SB204-21

Elite 6 Engine ECU Mount Improvement

Fig. 1

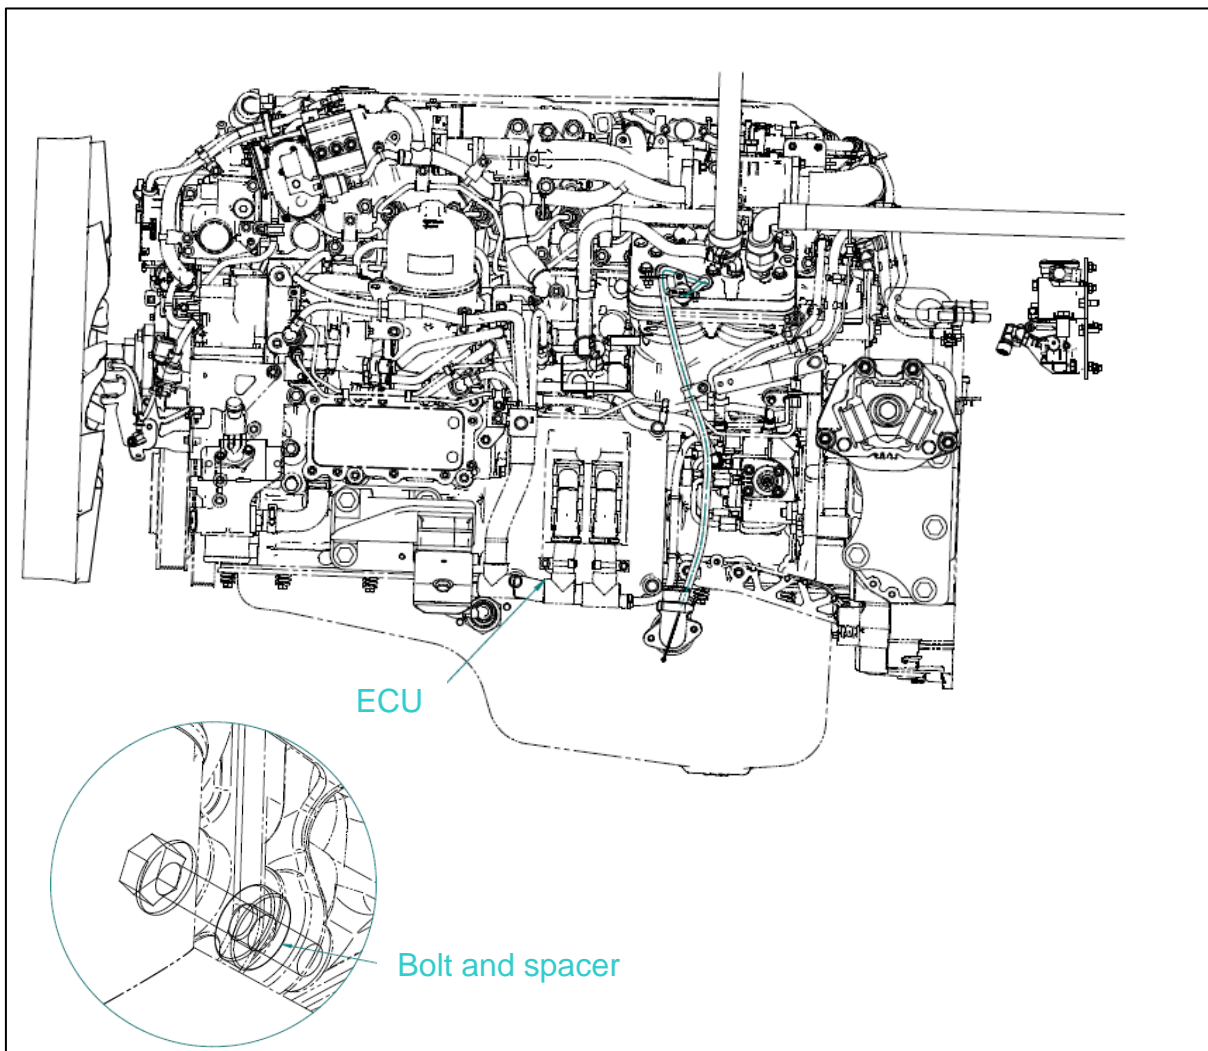
It is possible on the Elite 6 for debris e.g. stones to make their way into the area behind the engine ECU. If the stones do not work their way out it is possible for them to rub through ECU causing irreparable damage.

Fig. 1 below shows the position of the engine ECU and the spacer positioning.

To overcome this problem a simple fix is in place to space the lower rubber mounts out by adding 6mm spacers and longer bolts, production vehicles leaving DE are to this standard.

Fig. 2

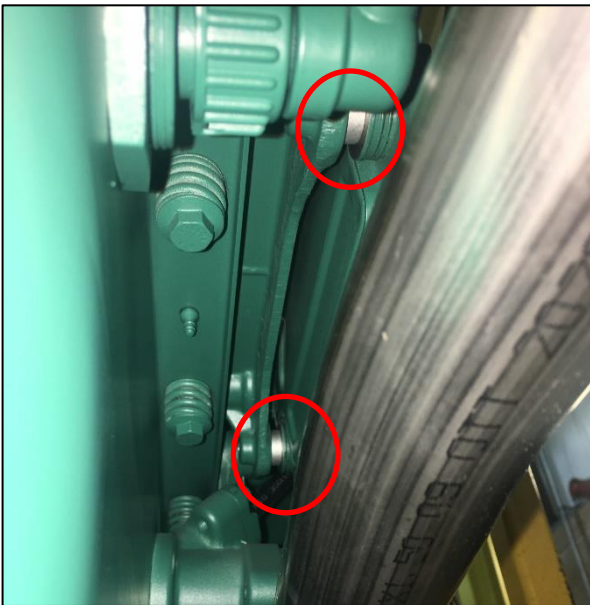
Fig. 2 shows the spacers mounted.

Bolts should be torqued to 25 Nm.

To apply this upgrade order part number SL1277 from DE parts on 01926 458555.
